PROJECT: Temple Sinai

**RESPONSE TO COMMENTS
ON THE
UPDATE TO THE TECHNICAL DRAINAGE STUDY
FOR
TEMPLE SINAI**

CITY OF LAS VEGAS		DATE:
INTER-OFFICE MEMORANDUM		May 29, 2013
TO: Land Development Services Department of Public Works		FROM: Albert Sung, P.E. Flood Control Project Engineer Department of Public Works
SUBJECT:	COPIES TO:	
Drainage Study for:	G.C. Wallace Companies	
Temple Sinai	Temple Sinai of Las Vegas	
Cross Streets:	Hillpointe Road & Pinewood Hills Drive	Bart Anderson, P.E., DevCo
File Number:	F:\Depot\DSMemos\DS4601A.doc	
Parcel Number:	138-20-212-002	
Zoning Action:	CRG-xxxxx; SDR-xxxxx	
FEMA Flood Zone	YES	NO X
Proposed Storm Drain	YES	NO X

**Re: Response to Comments on the Technical Drainage Study for Temple Sinai
DS4601A**

MARK D. LEVIN, AIA
TEMPLE SINAI
GRADING PLAN
DRAWING **C-6**
6 OF 7 SHTS

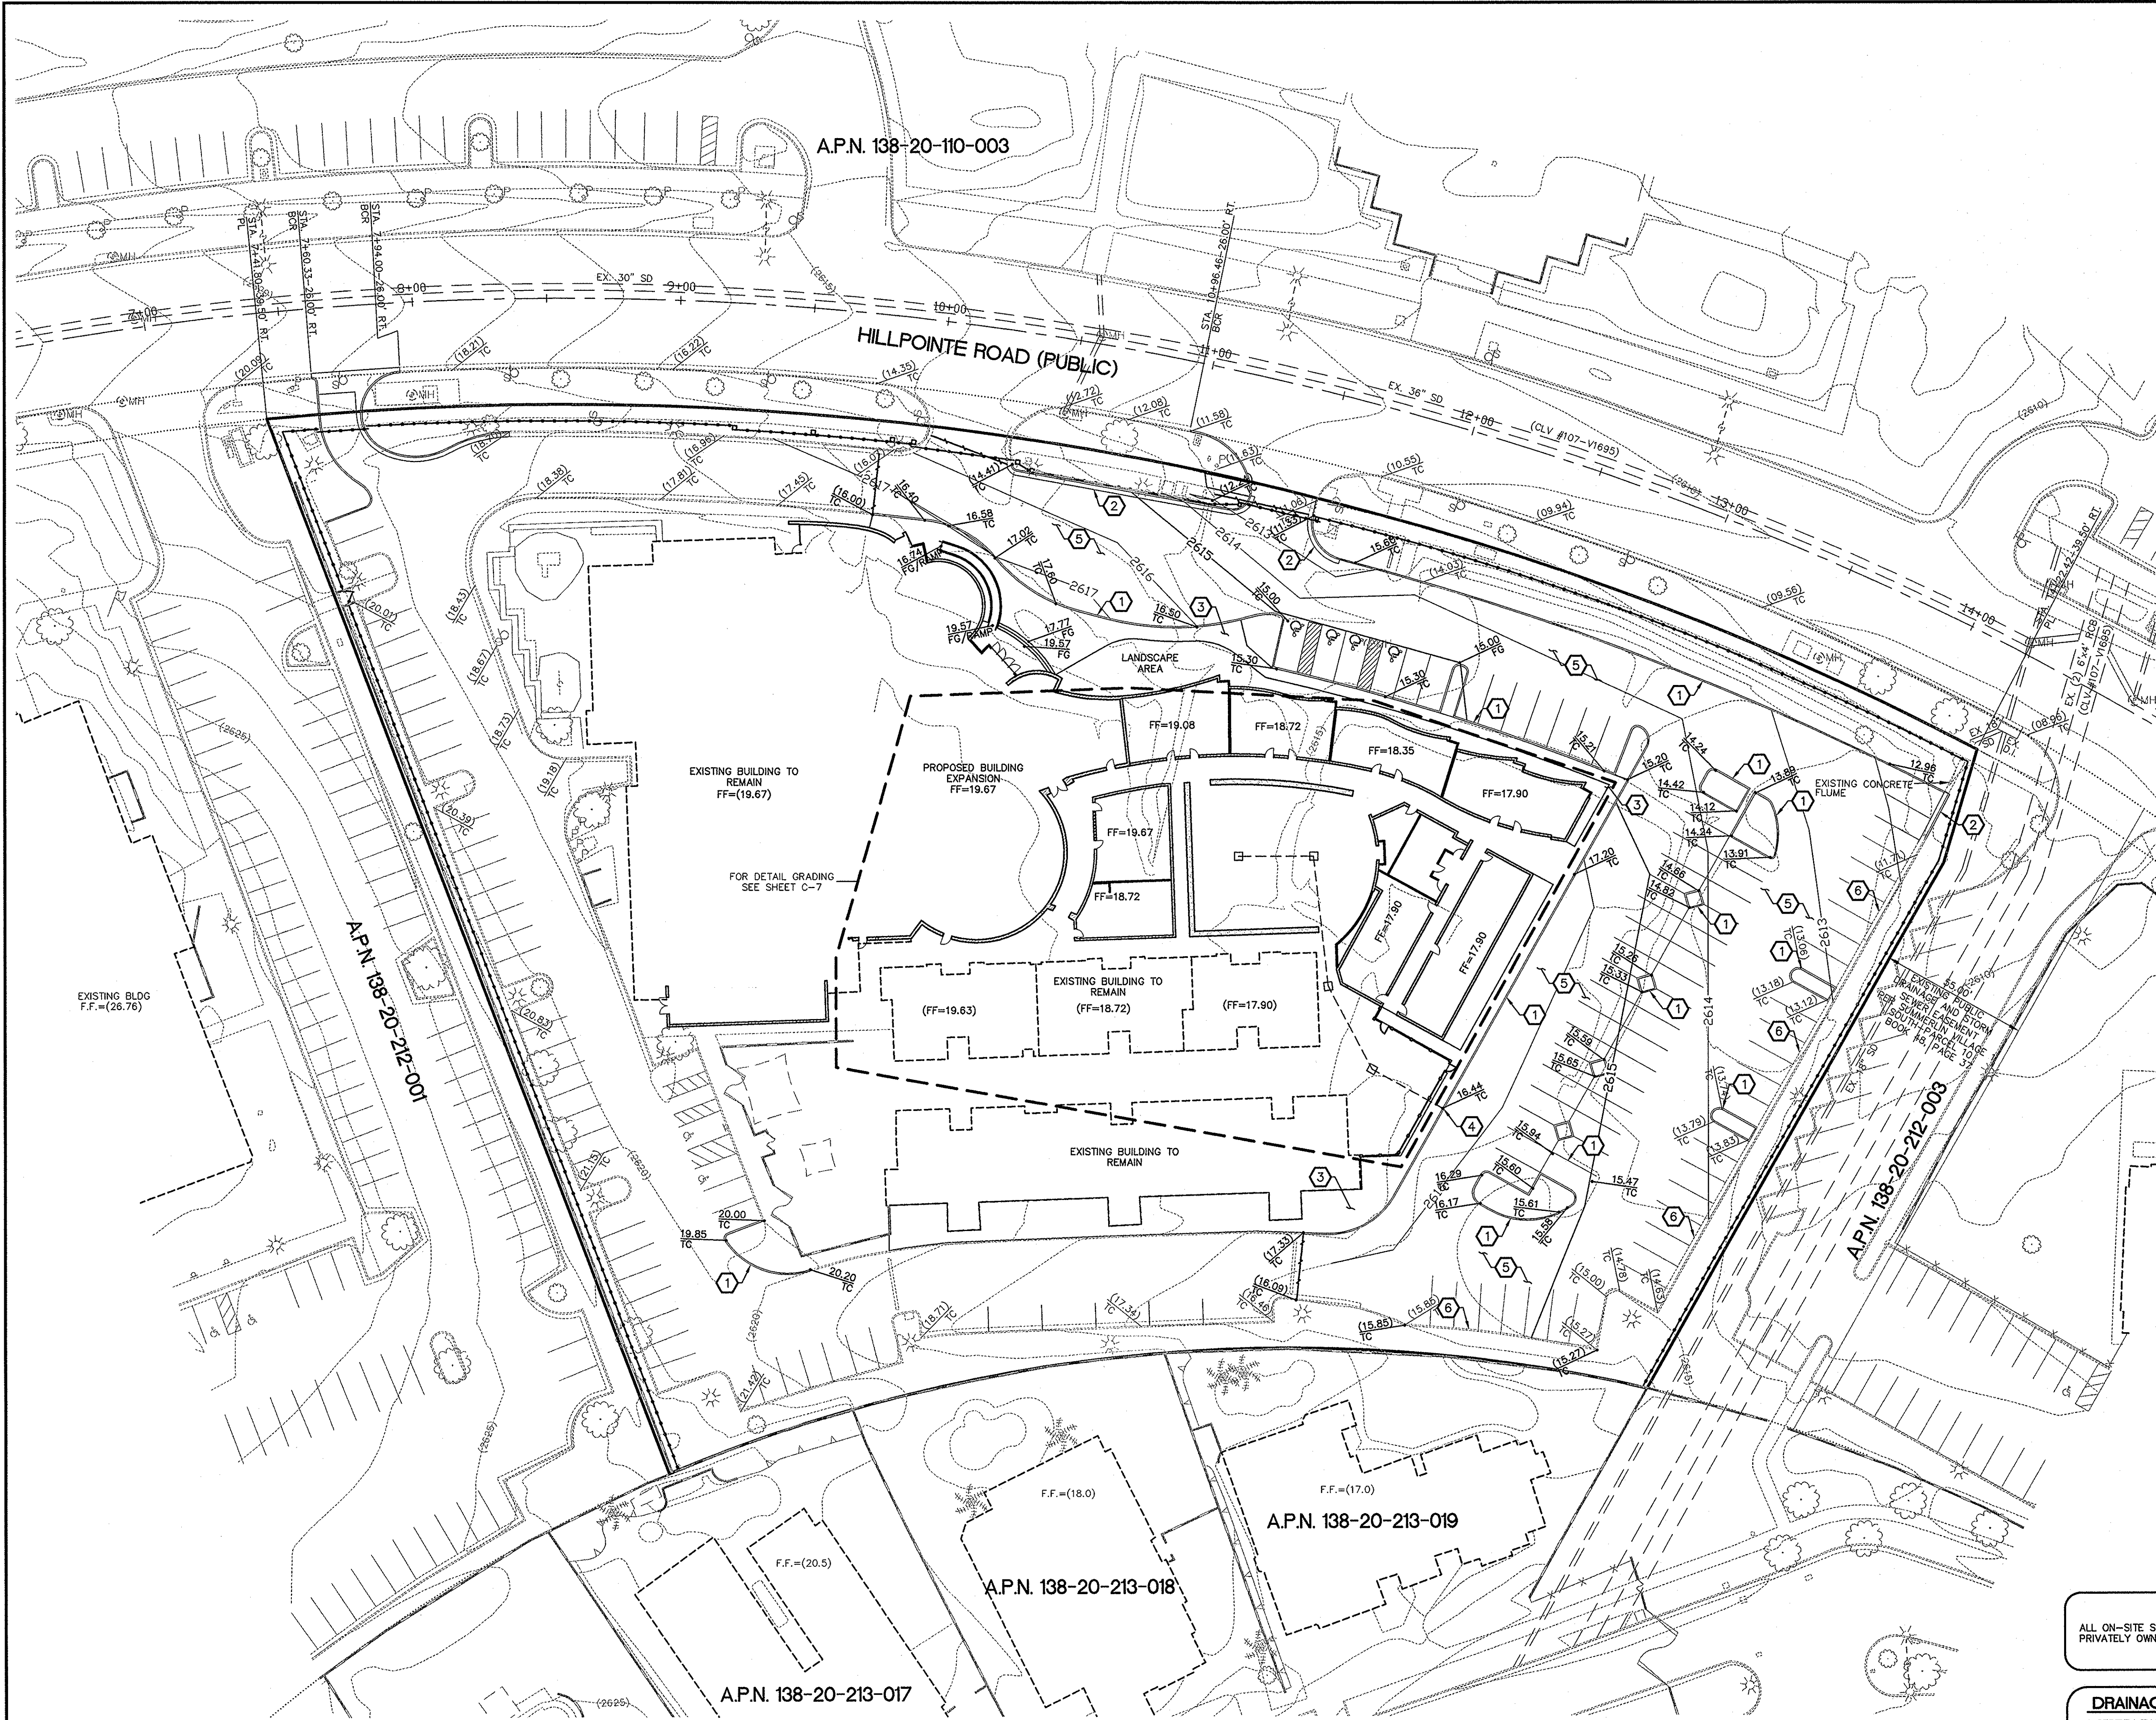
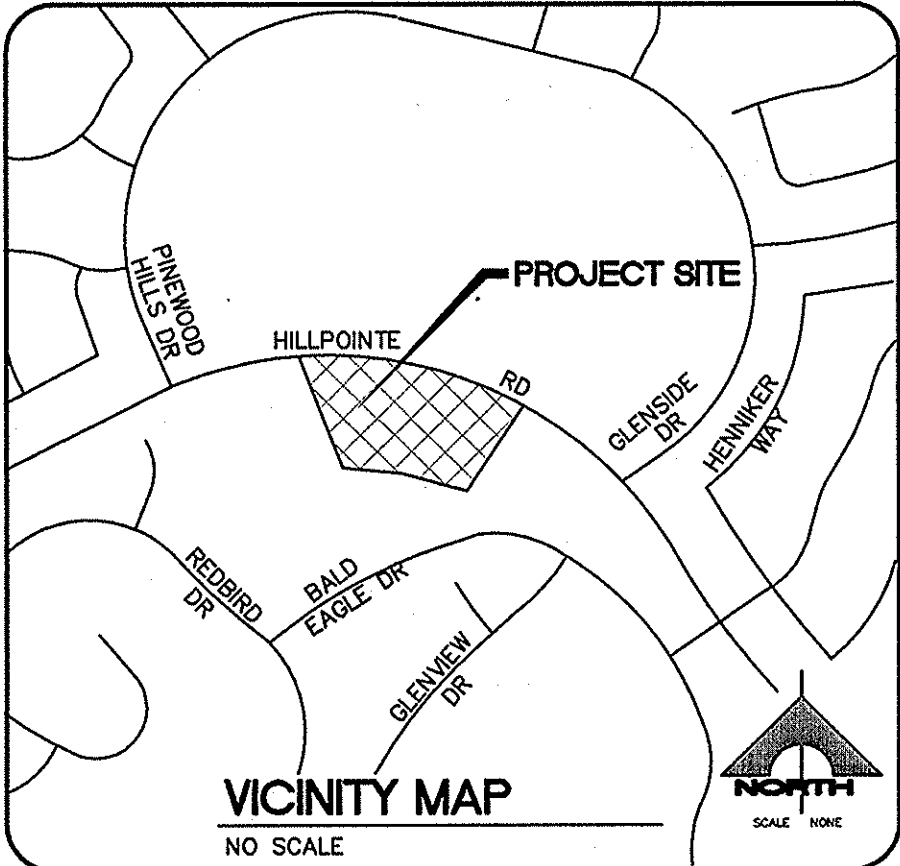
Comment: "2. Revise the onsite storm drain note on the grading plans to the fact that the storm drain system and the associated facilities are owned and to be privately maintained by **TEMPLE SINAI**."

- Comment:** "4. Identify an existing public drainage easement in the adjacent property to the east. Label with the width of the easement and the recorded document number on the grading plan. Also identify the storm drain systems running under the drainage easement."

- Response:** The existing concrete flume has been called out on the grading plans.
- Comment:** "6. Show an existing storm drain with all pertinent drop inlets and laterals, etc. in *Hillpointe Drive*. Label with pipe and inlet sizes and *City of Las Vegas* recorded drawing number on the plans."

- Response:** Hillpoint Drive has been labeled on the grading plans.
- Comment:** "8. Label the finish floor elevation of existing houses adjacent to the south and the LDS building to the west of the subject improvements."

Response: The onsite storm drain note on the grading plans has been revised.

- Response:** The existing 55-foot wide drainage easement has been identified and labeled on Sheet C-6.
- Comment:** "5. Identify an existing concrete flume at the northeast corner of the site for the surface discharge of the subject development."

- Response:** The existing storm drain facilities are and have been labeled accordingly.
- Comment:** "7. Label the street name of Hillpointe Drive on the grading plan."

Response: The finish floor elevation labels for the requested buildings have been added to the grading plans.
